# Access Compliance Report

## Public Rights-of-Way

Intersection ID: 14252	Main Street: BAXTER_ST	Cross Street: CECIL_ST	Location: NE
ADA ID: BD2EBF4C2FDF	Ramp Type: PerpDiag	Initial Pass/Fail: Fail	Overall Compliance: No
Severity Score: 13.75			
Codes/Mitigation Info/Possible Solution		Field Measurements/Component Compliance

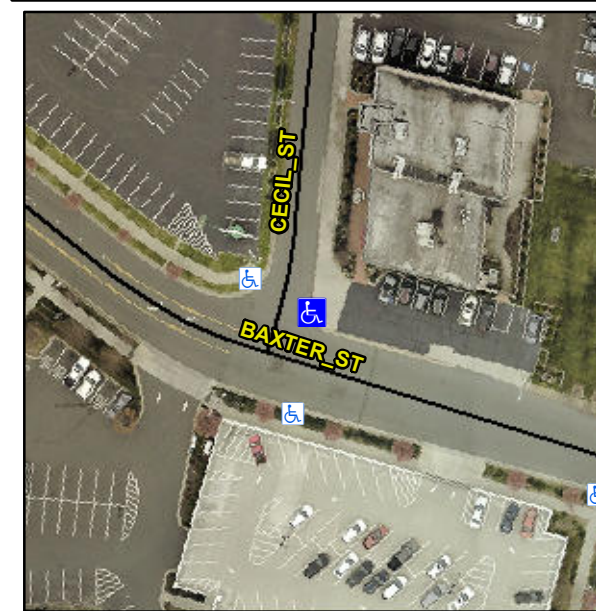
**Not Found, R304.2.2, R304.5.3**

Compliance	Description	Data	Compliance	Description	Data
N/A	Ramp Length (in)	41.0	No	Ramp Slope (%)	9.3
Yes	Ramp Width (in)	48.0	No	Ramp XSlope (%)	2.5
N/A	Flare Type LT	N/A	N/A	Flare Type RT	N/A
N/A	Flare Slope LT (%)	N/A	N/A	Flare Slope RT (%)	N/A
N/A	Flare Traversable LT?	N/A	N/A	Flare Traversable RT?	N/A
N/A	Landing Length (in)	N/A	N/A	DWS Provided?	N/A
N/A	Landing Width (in)	N/A	N/A	DWS Contrast?	N/A
N/A	Landing Slope (%)	N/A	N/A	DWS Length (in)	N/A
N/A	Landing X Slope (%)	N/A	N/A	DWS Full Width?	N/A
N/A	Landing Curb? (Y/N)	N/A	N/A	DWS Offset (in)	N/A
N/A	Shared Landing?	N/A			
N/A	Gutter Ponding?	N/A	N/A	Gutter Slope (%)	N/A
N/A	Gutter Lip Ht (in)	N/A	N/A	Gutter X Slope (%)	N/A
N/A	Painted X Walk1?	No	N/A	Painted X Walk2?	No
	X Walk 1 Direction	To NW		X Walk 2 Direction	To SW
N/A	X Walk 1 Width (in)	N/A	N/A	X Walk 2 Width (in)	N/A
	X Walk 1 Slope (%)	3.1		X Walk 2 Slope (%)	4.8
	X Walk 1 X Slope (%)	2.5		X Walk 2 X Slope (%)	2.3

**Remove & Replace Curb Ramp With Two New Directional Ramps or Equivalent.**
